VERMONT AGENCY OF TRANSPORTATION

PROJECT NAME: BENNINGTON
PROJECT NUMBER: AC NH 019-1(51)
FILE NAME: ...z307cldrn_plans_500.prf PLOT DATE: 2/3/2009
DESIGN SUPERVISOR: GREG EDWARDS DRAWN BY: STANTEC
DESIGNED BY: MARC FOISY CHECKED BY: GARY SANTY
DRAINAGE PLAN DP-02 SHEET 75 OF 367

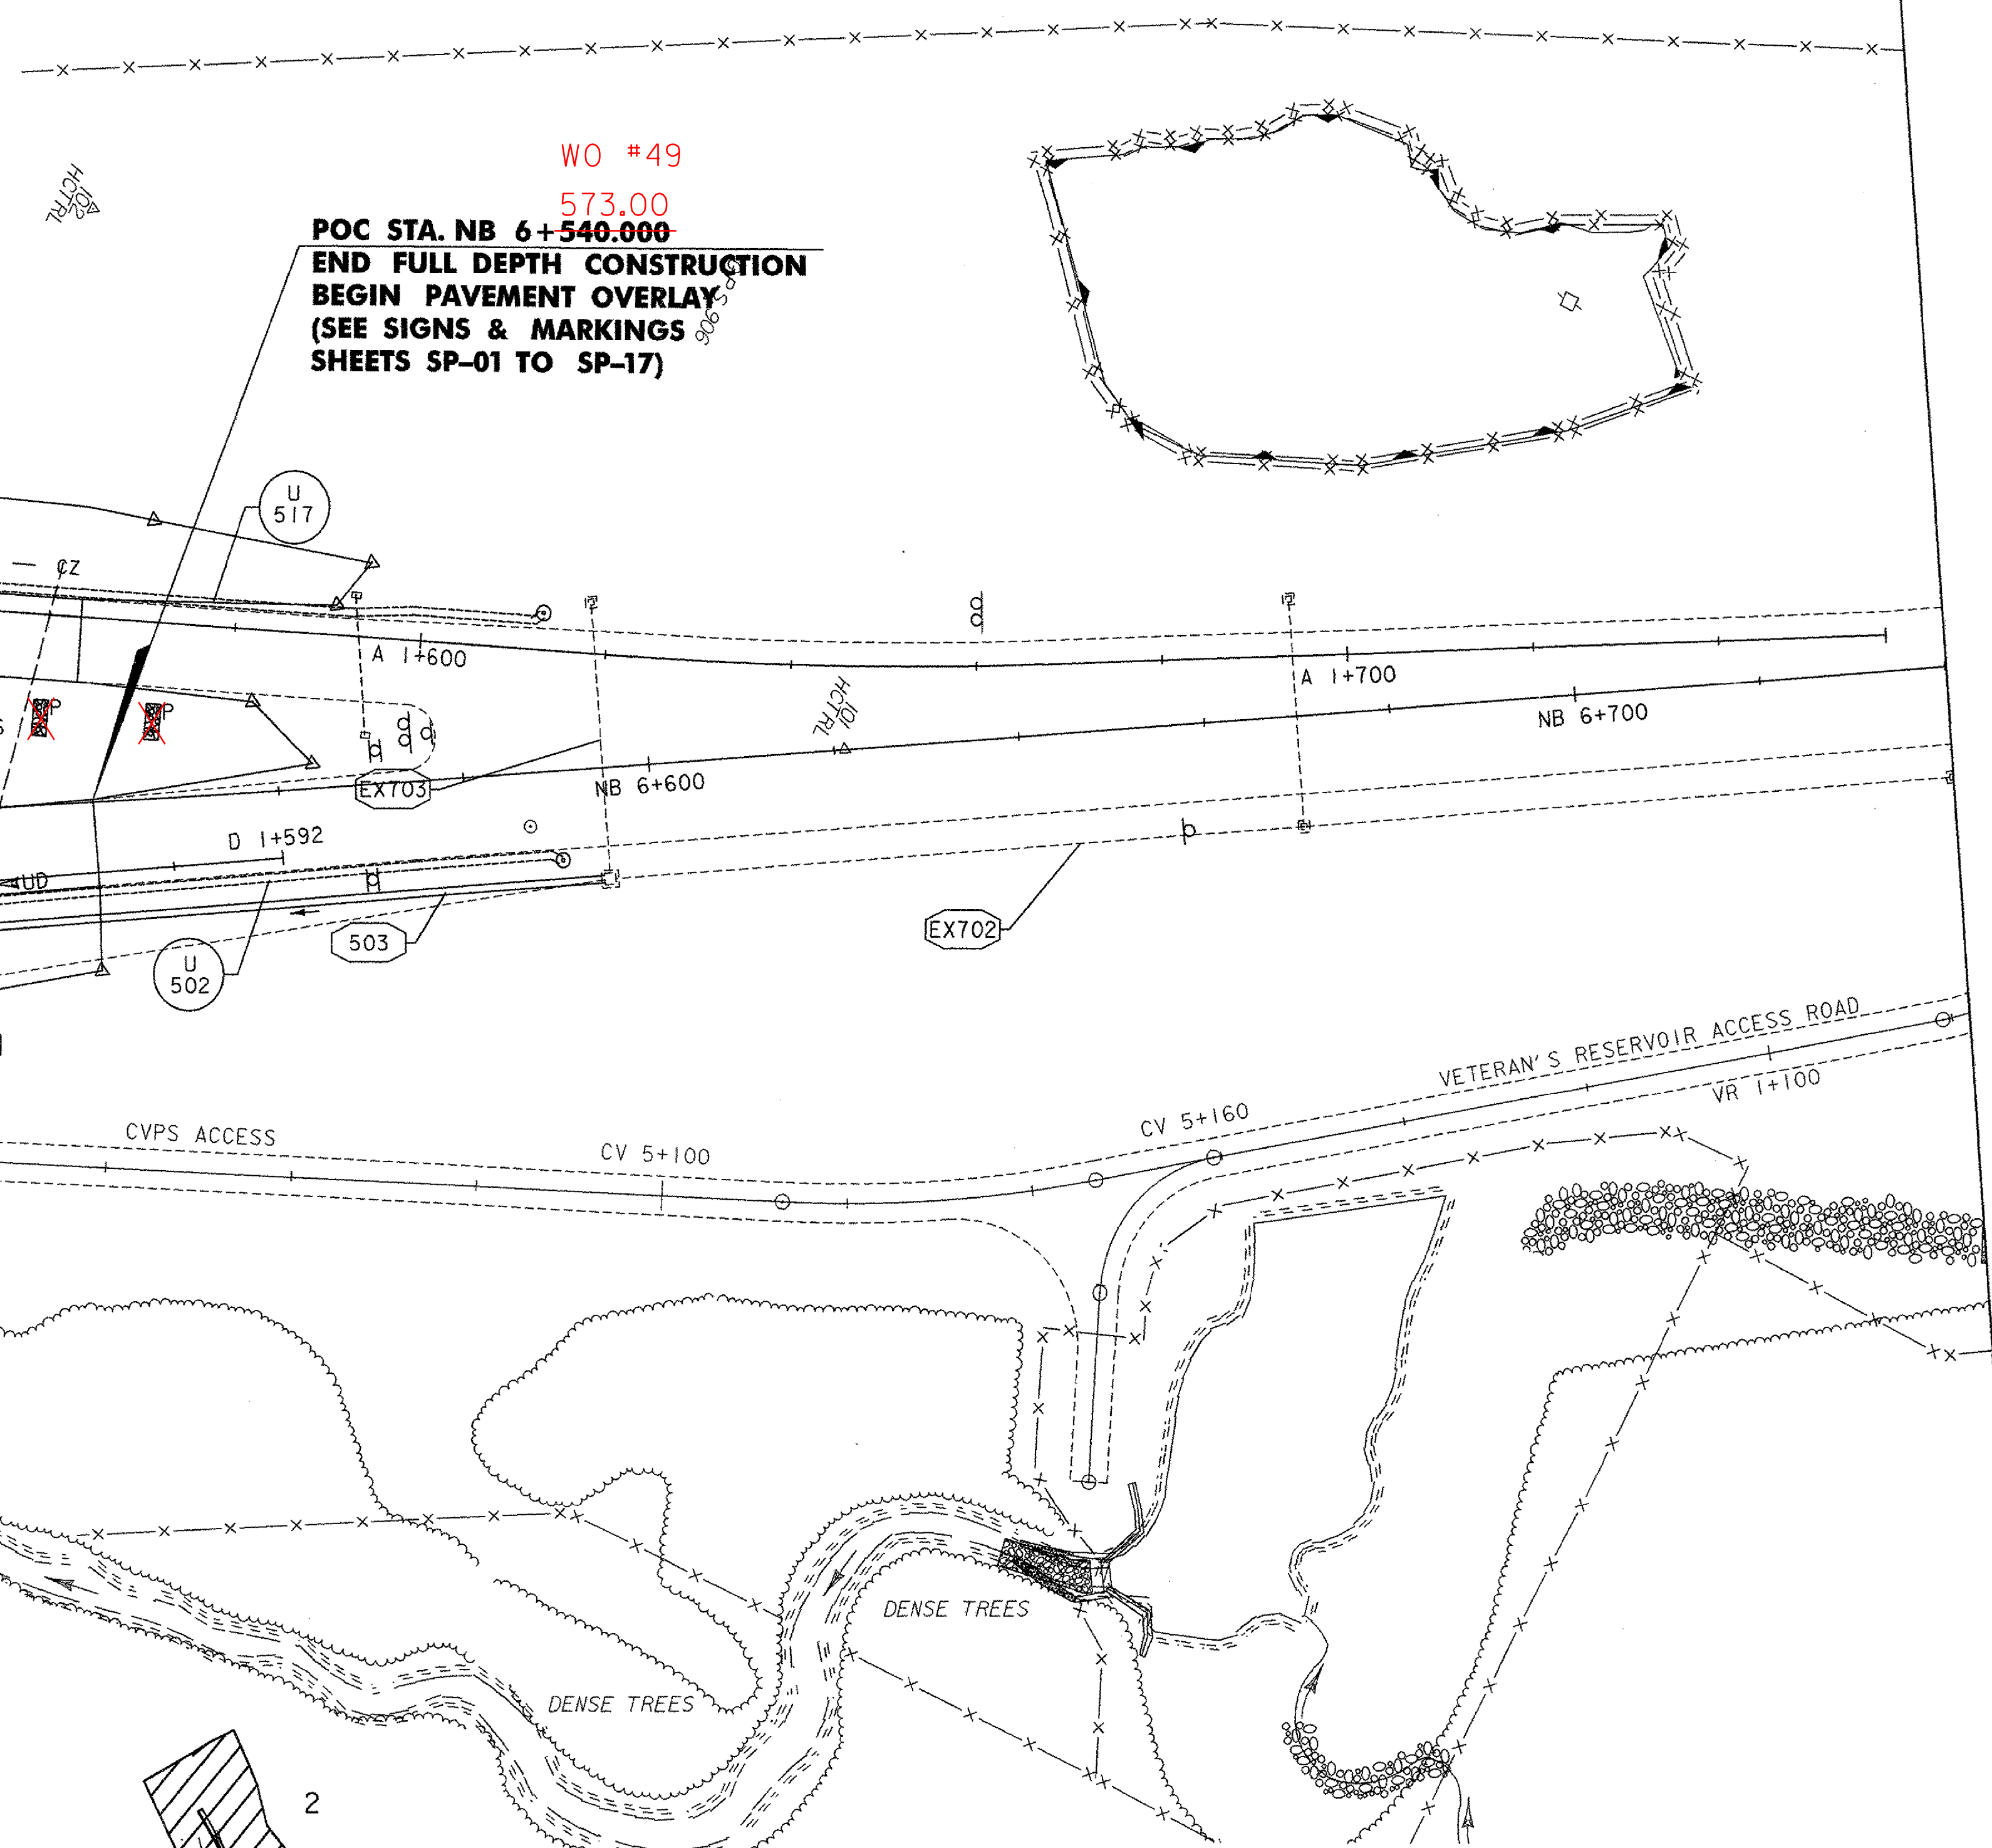
~~PERMANENT STONE CHECK DAM, TYPE 1
STA. A 1+410.0, 5.4m RT. STA. A 1+555.0, 4.6m RT.
ELIMINATED PER CHANGE ORDER #37~~
